Subject: Submittal of Final Work Plan to Investigate EBS Sites, Mound Area, EBS Site 109(7), Seneca Army Depot Activity; File No. 1017A

**WORK PLAN
INVESTIGATE EBS SITES,
MOUND AREA, EBS SITE 109(7)
SENECA ARMY DEPOT ACTIVITY
ROMULUS, NEW YORK**

Army's Response to Comments from the US Environmental Protection Agency

Subject: Draft Work Plan for EBS Site 109(7)
Seneca Army Depot
Romulus, New York

**FIGURE 1-1
LOCATION AND
PROPOSED SAMPLING PLAN
FOR THE MOUND AREA**

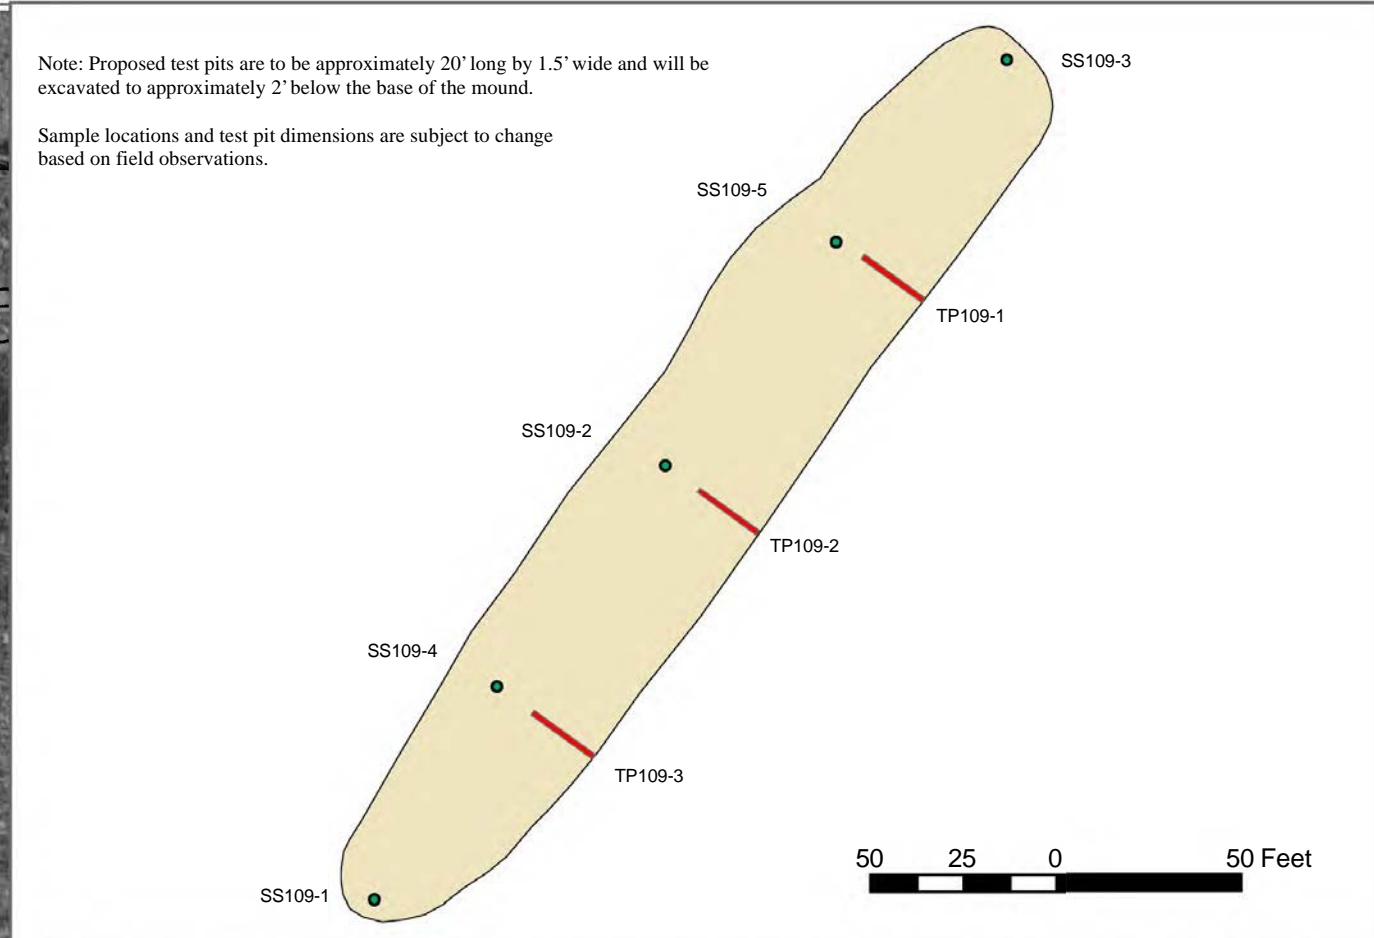
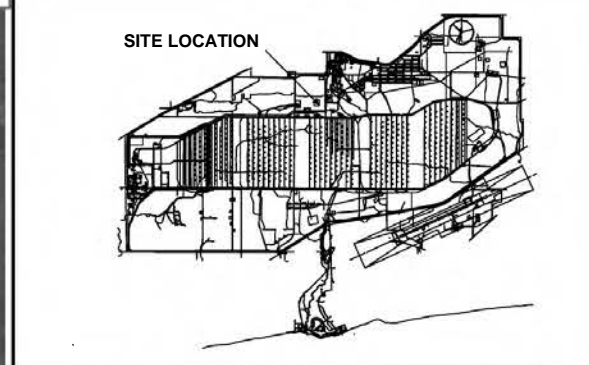
Comment 2: Additional documentation is needed for the cleared areas shown on Figure 1-1, as they may have been part of the same use that created the mound. A walk-through investigation should be completed for these cleared areas, noting anything observed on the surface, including: spent bullets, cartridges or other ammunition; distressed vegetation; discolored soil; discoloration of any ponded surface water; or any materials, debris, or fill that appears to be non-native to the forested area.

Comment 1: Section 1.2, Page 1-2. A discussion of surface water flow should be included in this section. It appears from Figure 1-1 that the nearest defined surface water drainage ditch is located to the east of the berm. Would all surface water flow from the site to this ditch, or does some migrate toward East Kendaia Road, Bundle Ammunition Pack Road, or other feature?

Comment 5: Section 3.2, Page 3-2. As noted previously, revise the first sentence to indicate that "At least five surface soil samples will be collected..." from the mound area. During collection of samples, anomalous soils may be encountered, justifying additional sampling. In addition, the sixth sentence of this section ("As discussed in....") contains a typographical error. The surface soil samples will be collected from the northwest side of the mound, not the southeast. Revise accordingly.

Response 2: As stated in the Work Plan in Section 1.2, a preliminary site walk was performed in November 2003. More extensive site observations at the site (i.e., the mound) and in the surrounding area will be recorded as part of the proposed site work. Results of this effort will be recorded in the field notes, and summarized in the report prepared for the limited site investigation. The examination of the area surrounding the Mound will be limited to observations based on visual inspections.

Response 1: The Army has not yet completed a detailed visual survey of the area surrounding the Mound. This will be performed as part of the limited site investigation. Based on a review of available topographic maps for this area, it is expected that the most likely surface water flow path would be towards the northeast to northwest quadrants. The regional surface topography is highest to the south of the piles, falling off towards the north. However, the overall gradient is shallow, suggesting that most storm water from vegetative areas would infiltrate. This information has been added to the text. Additional surface water flow information will be observed during the field program, and noted in the subsequent report.

Response 5: As stated above, the scope of work outlined in the Work Plan is adequate for a limited site investigation. Therefore, only five surface soil samples will be collected from the Mound. The sixth sentence refers to the nine soil samples collected in the test pits, which are correctly identified as located on the southeast side of the berm (Figure 1-1).
